JSP25-32 CATHOLIC CENTRAL CLASSROOM ADDITION

Public hearing at the request of Catholic Central High School for Planning Commission's approval of revised Special Land Use Permit, Preliminary Site Plan and Stormwater Management Plan. The applicant is proposing an addition to the southeast area of the main building.

Approve/Deny the revised Special Land Use permit, Preliminary Site Plan with phasing, Woodland Permit and Stormwater Management Plan.

EXISTING TYPICAL AREA LIGHT

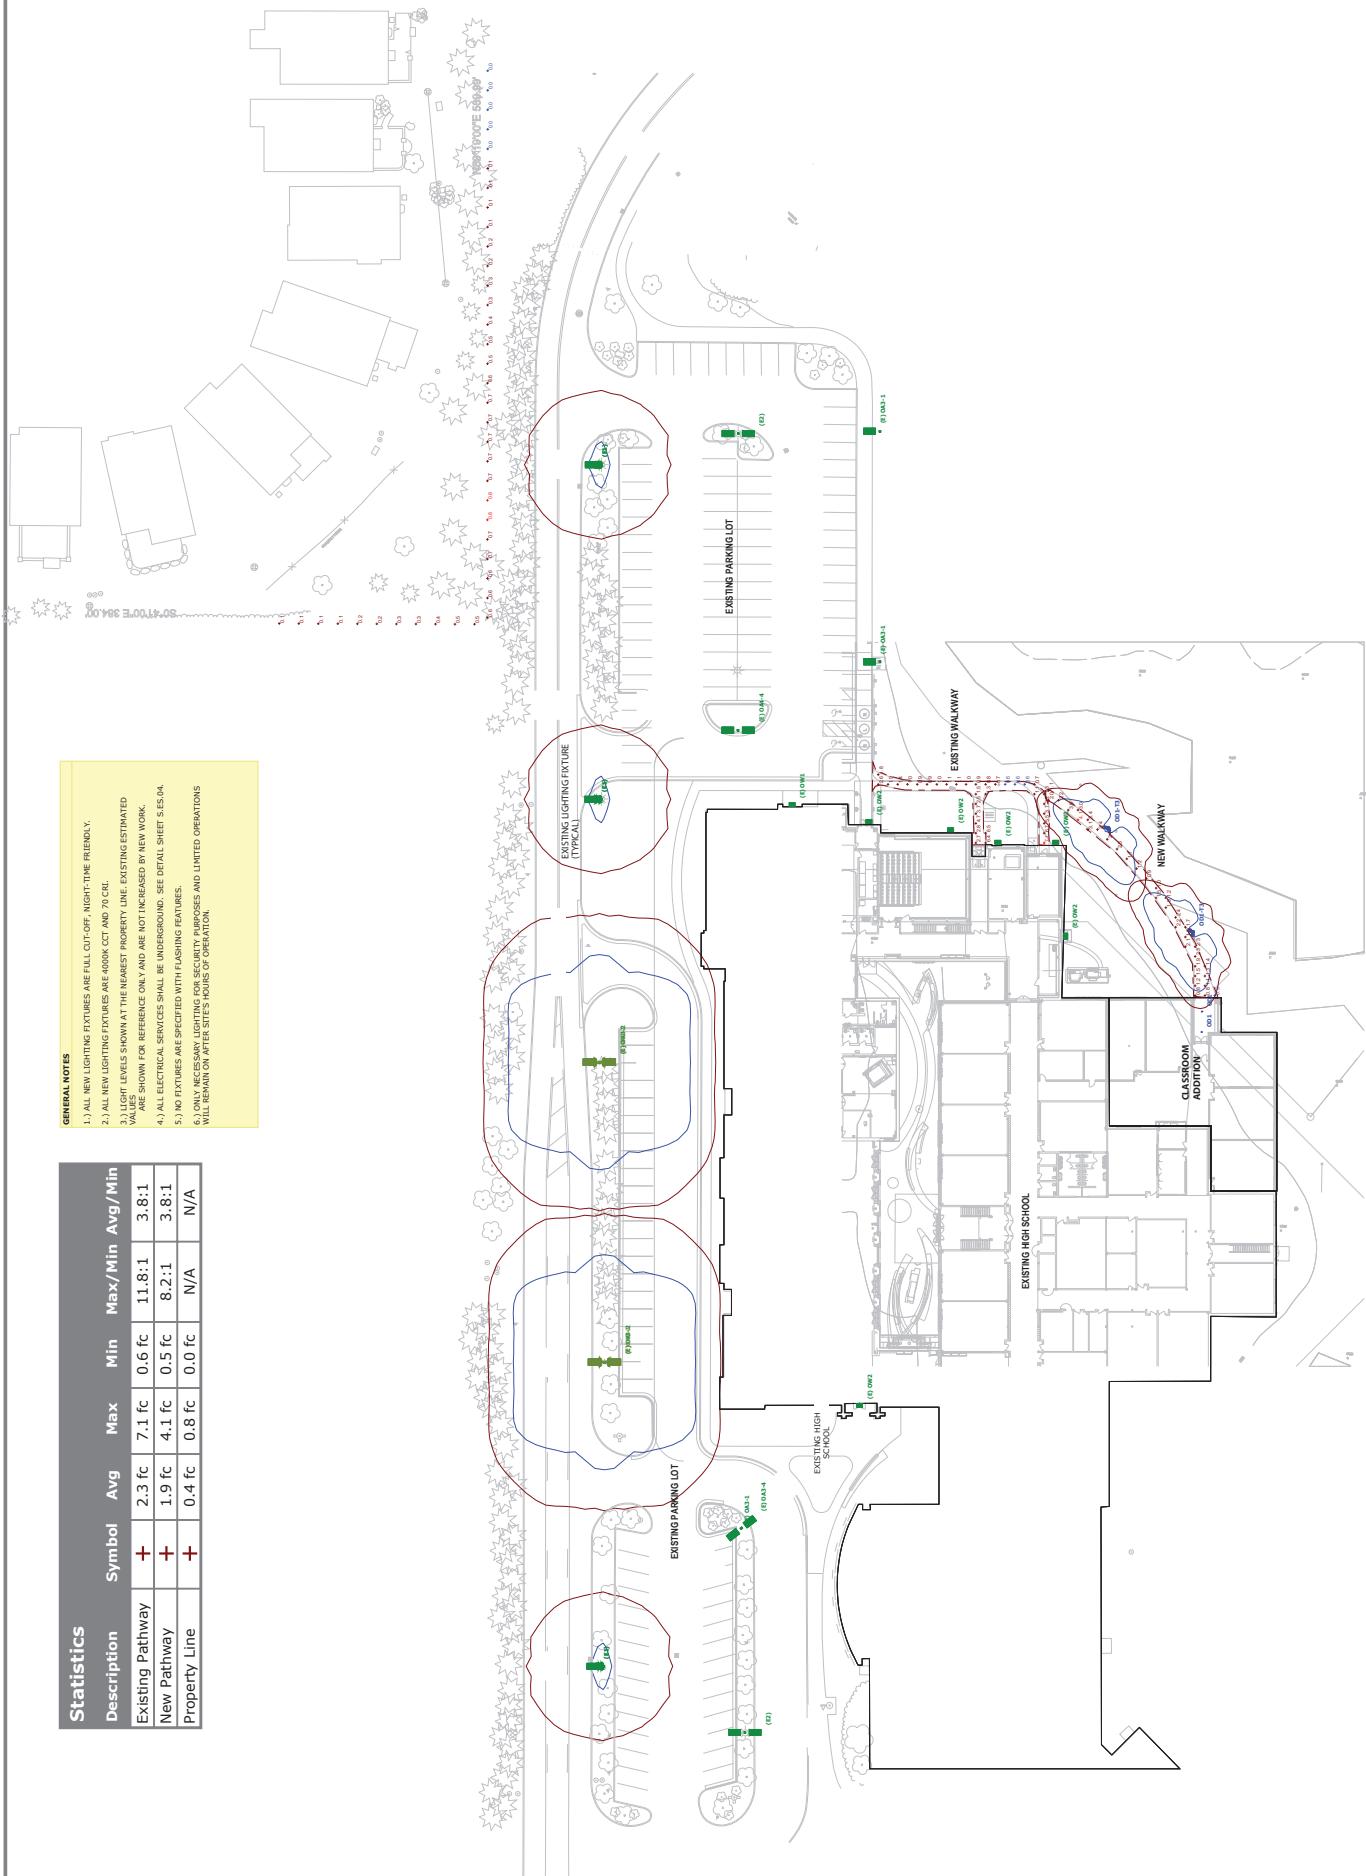
2. Lighting – Color Spectrum (Sec. 5.7.3.F.): The Ordinance requires all permanent lighting installations to have a Correlated Color Temperature of no greater than 3000 Kelvin. The lighting plan shows new fixtures proposed have a CCT of 4000 Kelvin. **The applicant should comply with the ordinance, or seek a variance from the Zoning Board of Appeals.**

Figure 1. City of Novi Regulated Woodlands Map

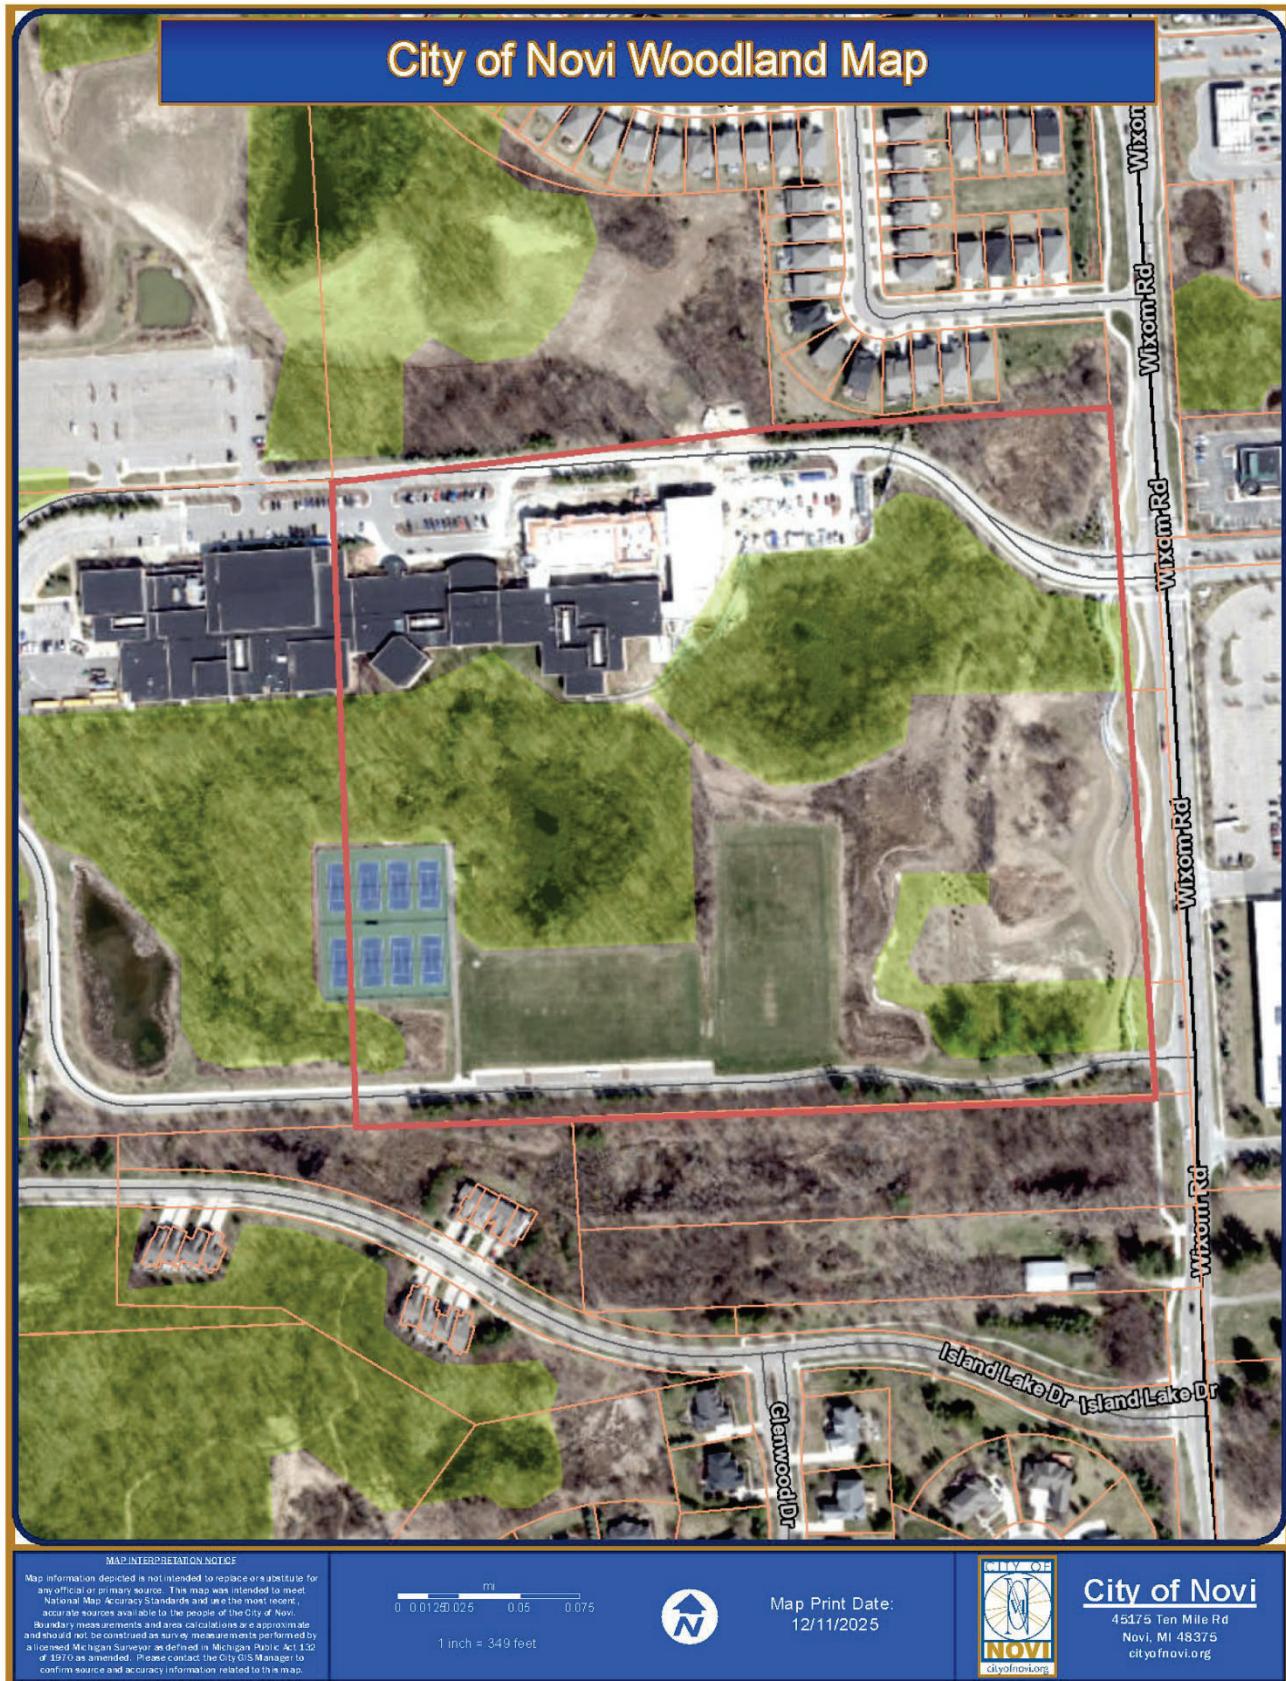
1. City-regulated woodlands, as identified on the City of Novi Woodlands interactive map website, are present onsite. Note that both the woodlands and property limits depicted on the City map are considered approximations (**Figure 1**). Merjent conducted a site visit on December 11, 2025 to compare the conditions in the provided PSP relative to the woodland on-site. Select photos from the site visit is included in **Attachment A**. The site visit revealed that the information presented in the PSP and on the City's Woodland Mapper are accurate.

Attachment A
Site Photographs

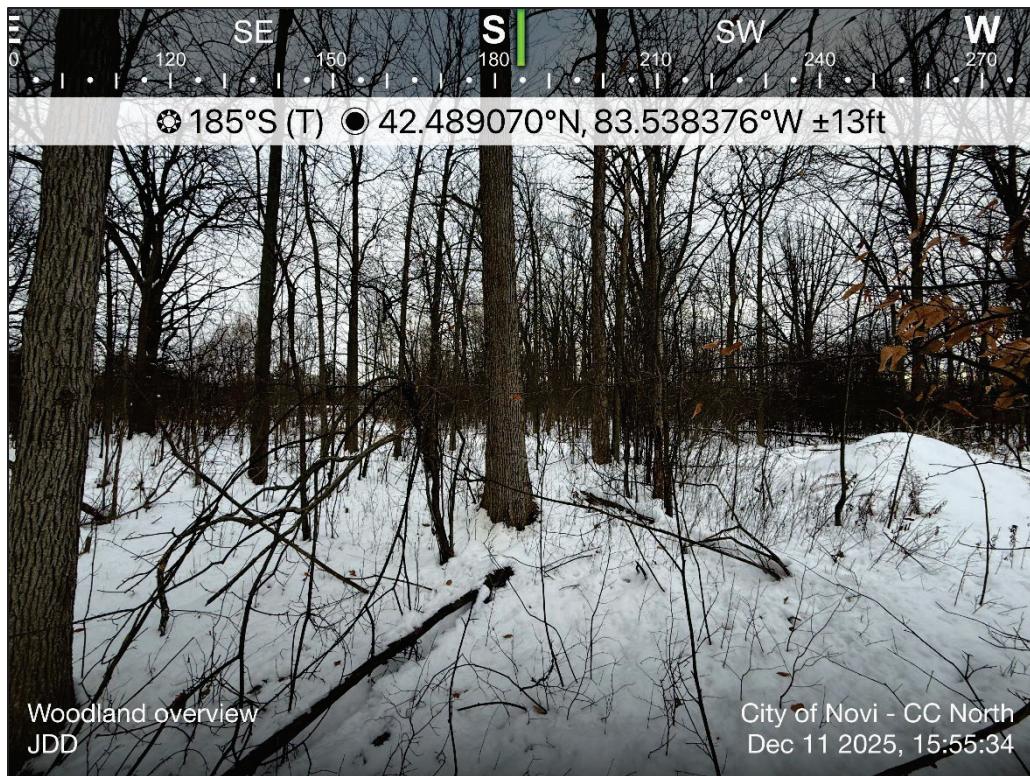
Overview of location where additional classroom is proposed
